ADDENDUM NO. 6

Project Name Q-Kids Childcare Project

Date Issued July 22, 2022

ELECTRICAL ADDENDUM #01

E3.0

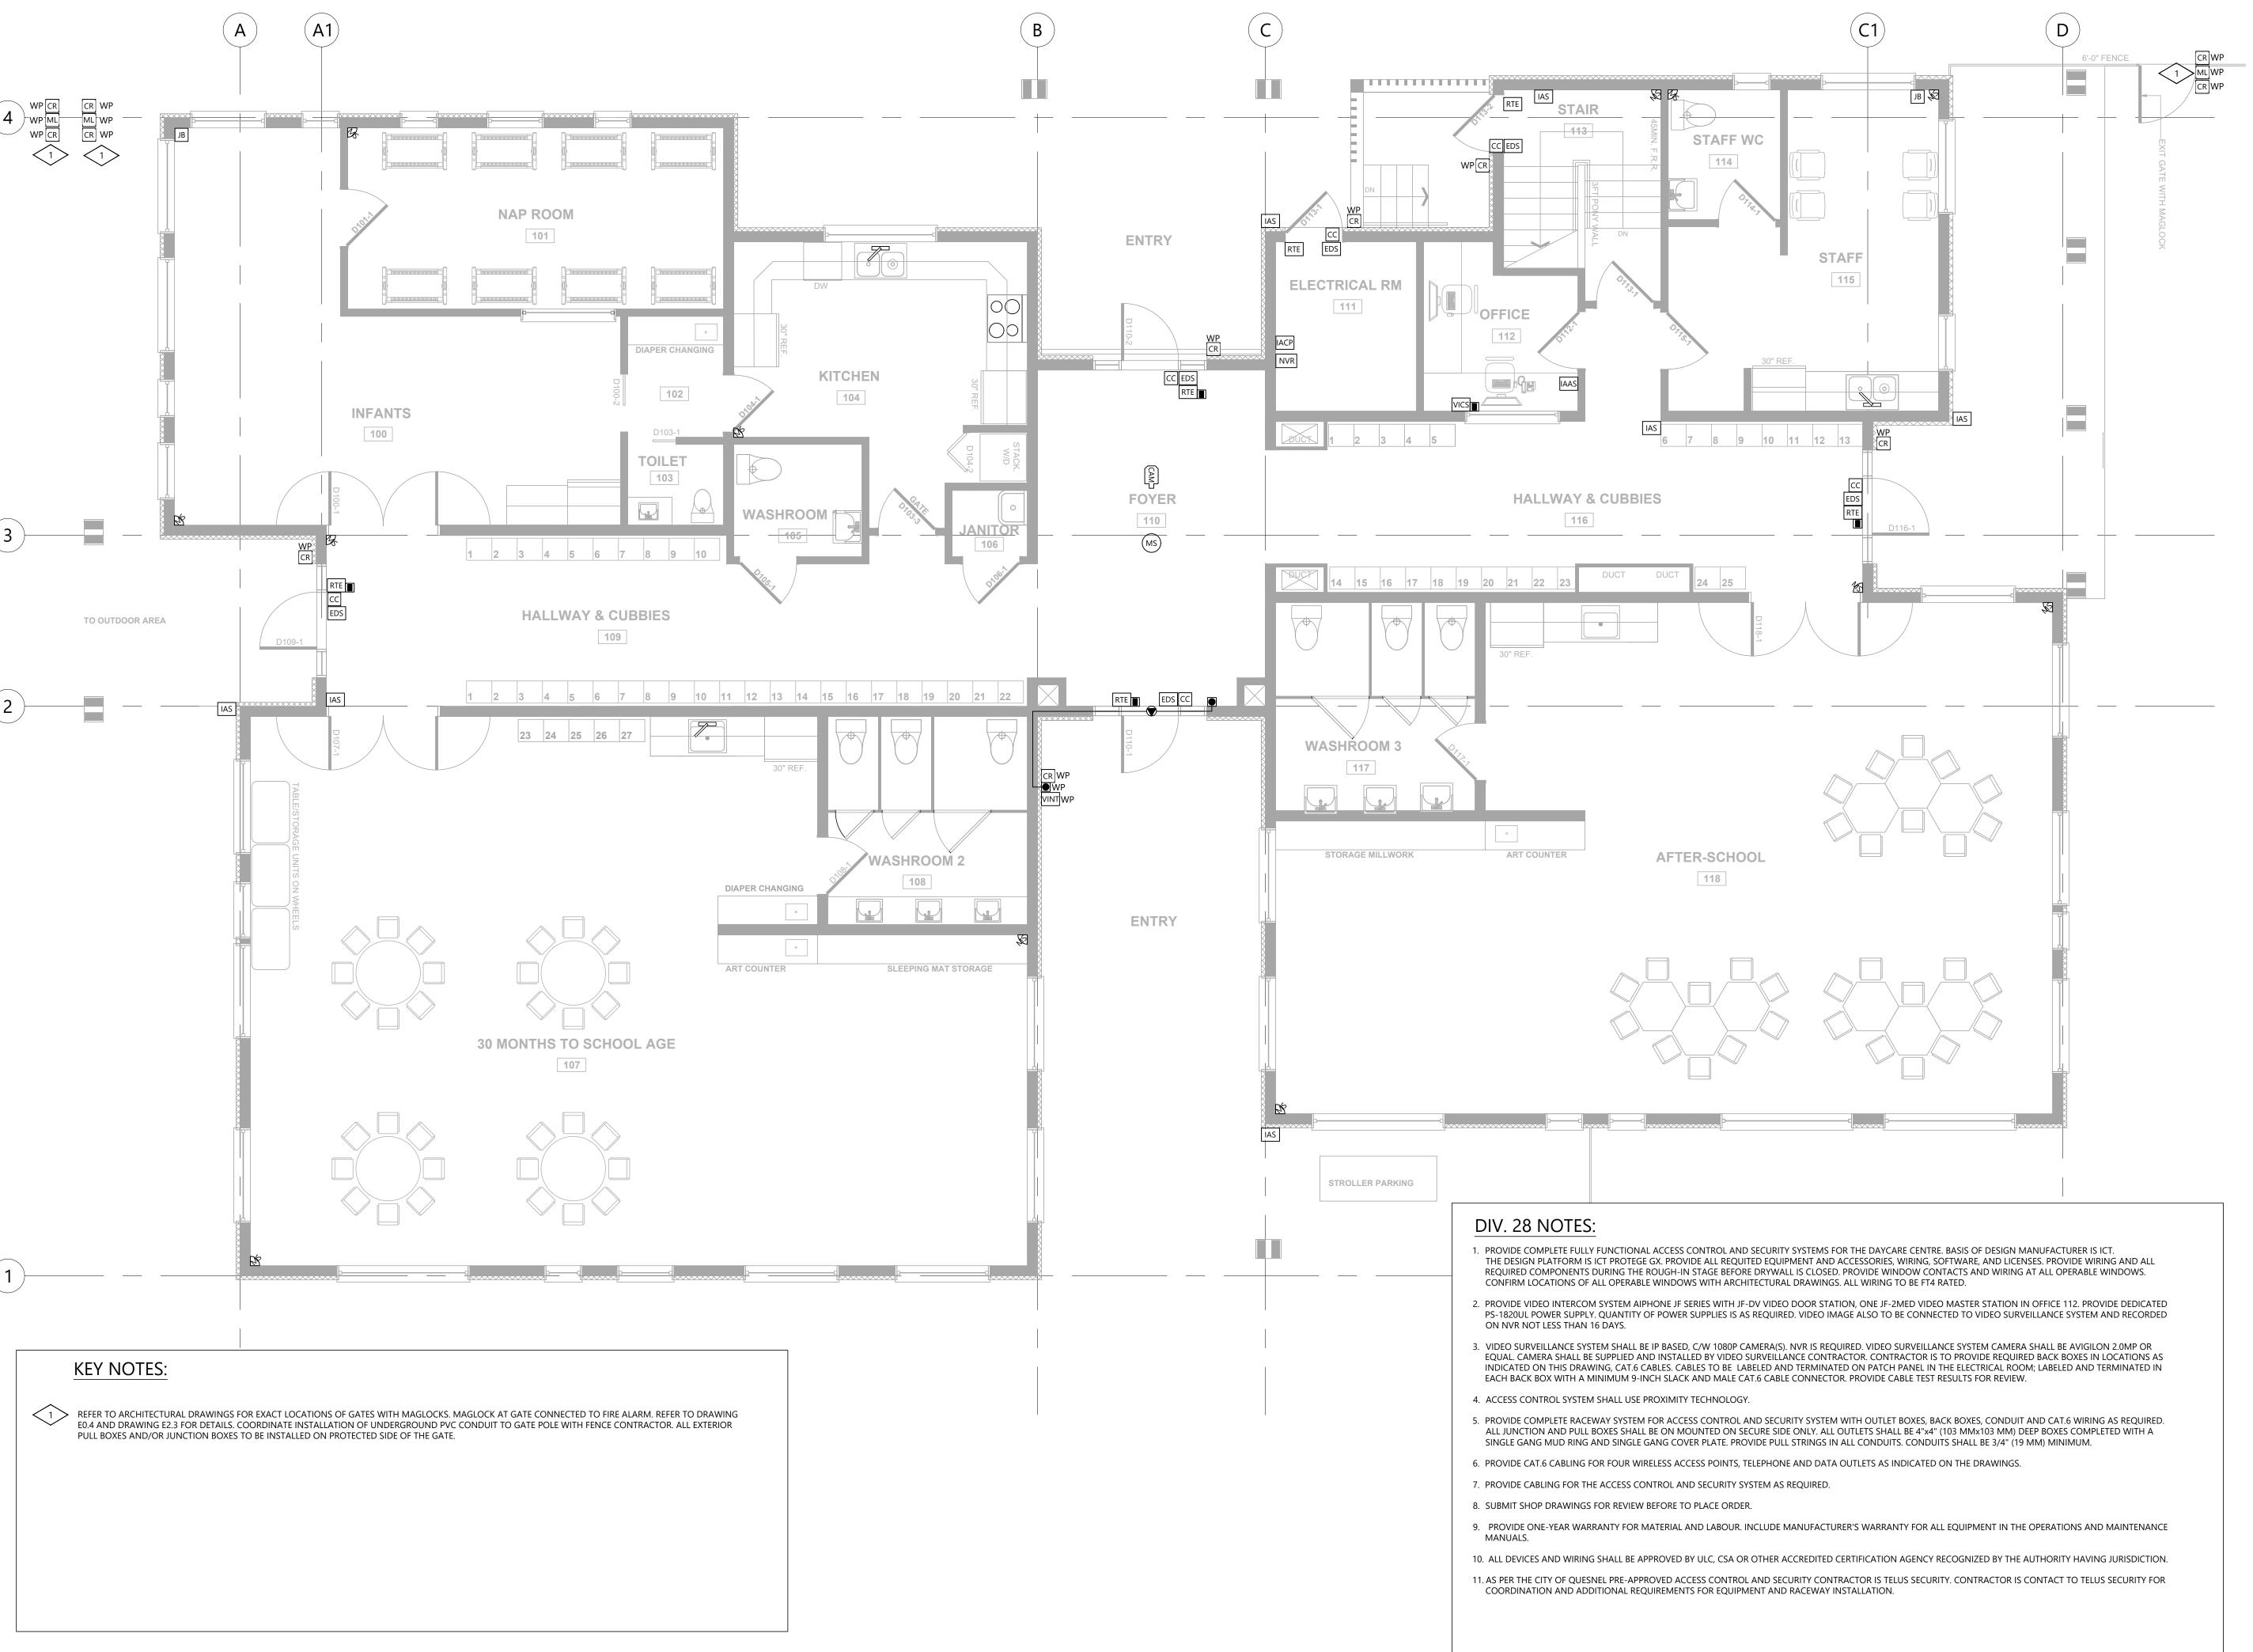
- 16. Add lighting control and EM remote head in Toilet 103 as shown.
- 17. Washroom 2 108 and Washroom 3 117 luminaires to be Type A1 as shown.
- 18. Outdoor scones to be Type F. Refer to attached updated Drawing E3.0.
